CASE COMMENT REPORT

CASE NO. UDP-P25001

CASE	UDP-P25001
PROJECT NAME	Bayview 1100 Plat
APPLICATION TYPE	Plat Review
APPROVAL LEVEL	DRC, Planning and Zoning Board Approval, City Commission Approval
REQUEST	Boundary Plat
APPLICANT	Sunrise and Bayview Partners, LLC.
AGENT	Jeff Hodapp, Perimeter Surveying and Mapping, Inc.
PROPERTY ADDRESS	1100 Bayview Drive
GENERAL LOCATION	Coral Ridge South Add 24-41 B Lot 1,2 Blk 1 And Bay Park Revised Plat 25-15 B Tr 5 W 130
ZONING DISTRICT	Residential Multifamily Mid Rise/ Medium High Density (RMM-25) and Residential Multifamily High Rise/High Density (RMH-60)
LAND USE	High Residential
COMMISSION DISTRICT	1 - John Herbst
NEIGHBORHOOD ASSOCIATION	Coral Ridge Association
SUBMITTAL	February 3, 2025
COMPLETENESS ISSUED	February 7, 2025
EXPIRATION	August 7, 2025 (180 Days)
WAIVER	Not Requested
CASE PLANNER	Yvonne Redding, Urban Planner III

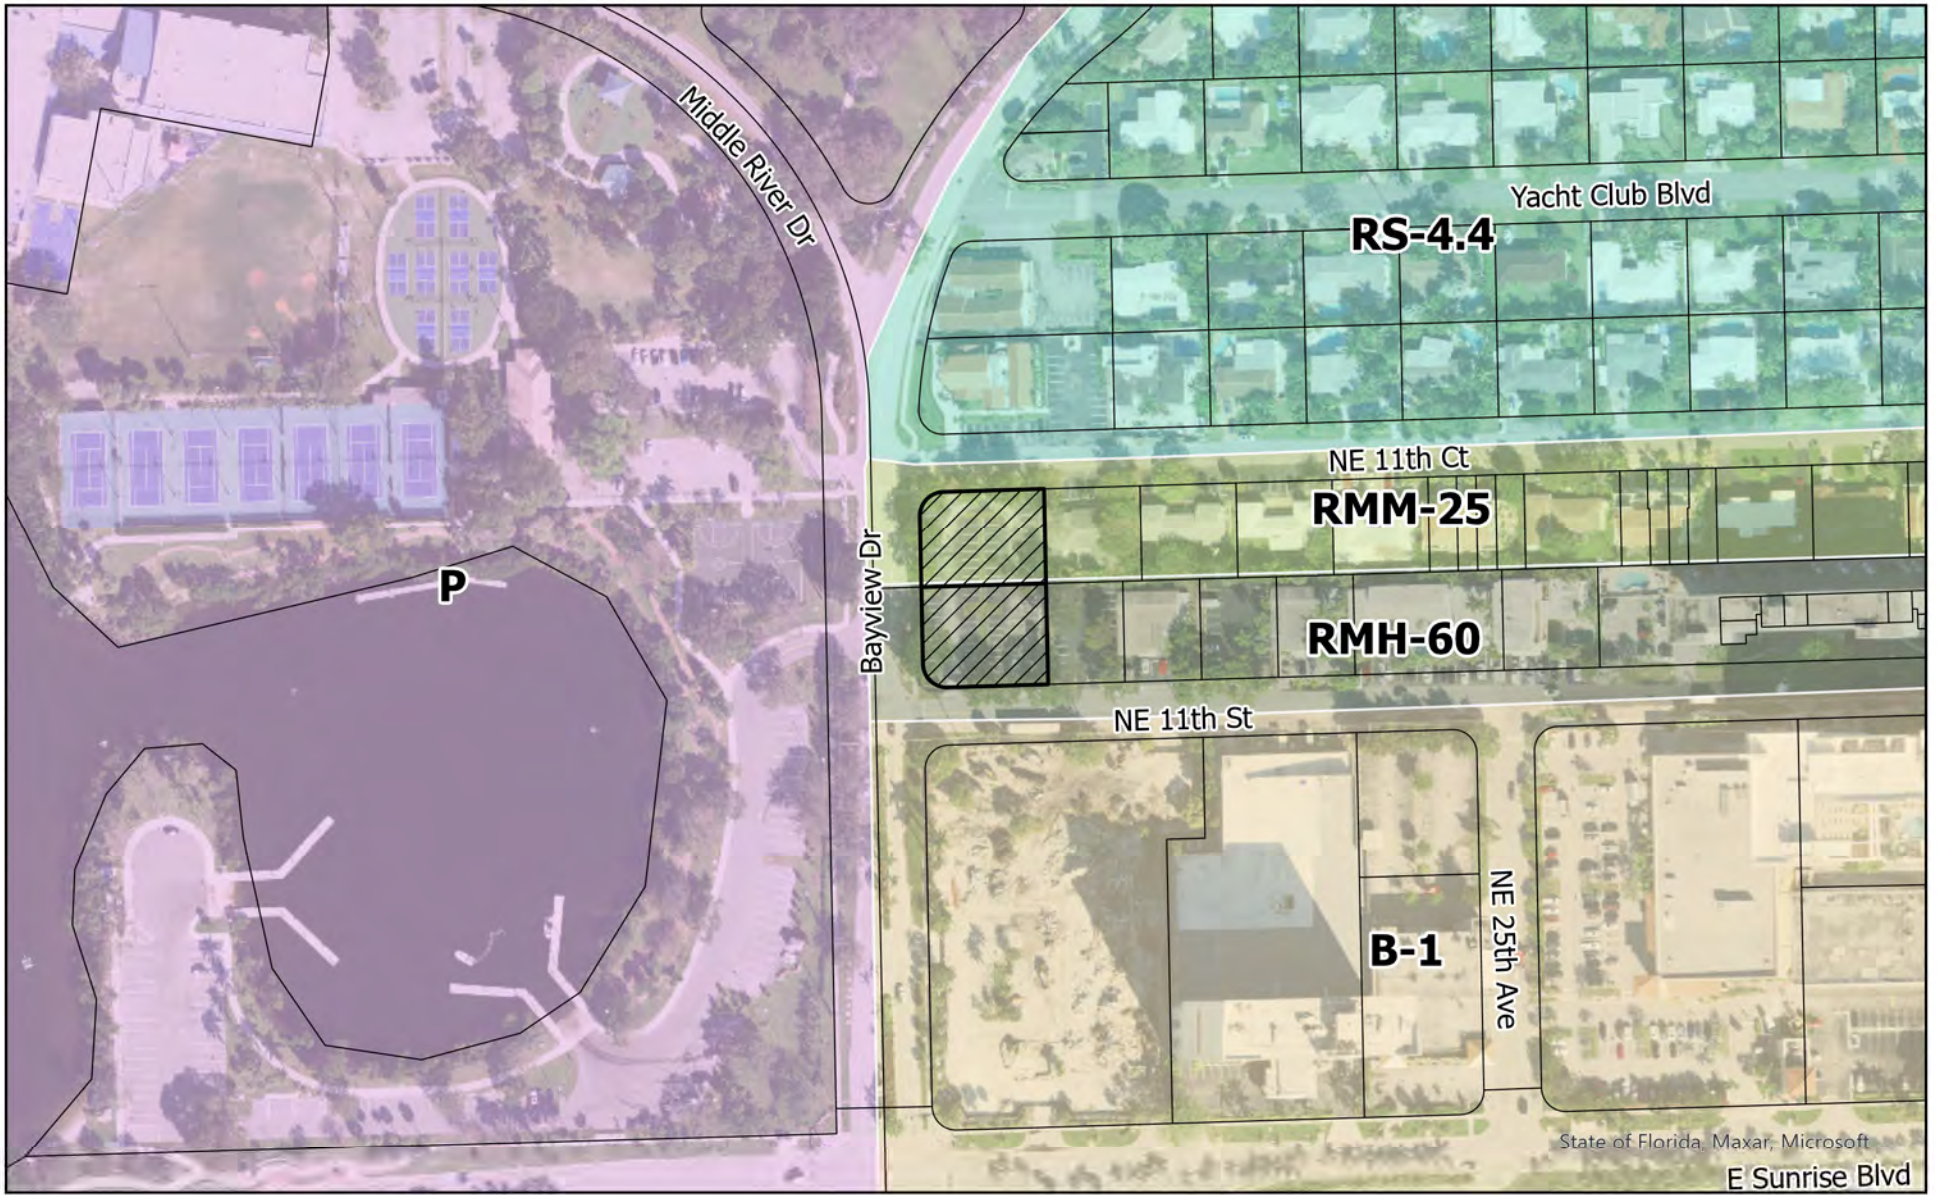
- a. Stormwater Operations does have stormwater concerns as they relate to this plat review.
- b. As depicted in the stormwater atlas below our concerns are tied to the following
 - i. Existing stormwater infrastructure that runs parallel to the parcel
 - 1. 3 inlets
 - 2. 3 > 24 in gravity mains
 - ii. Private but connected privately owned stormwater infrastructure that will need to be properly abandoned
 - 1. I would recommend that the contractor be obligated to conduct a pre and post CCTV of all City owned stormwater assets currently connected to document the condition of the existing pipe prior to the abandonment.
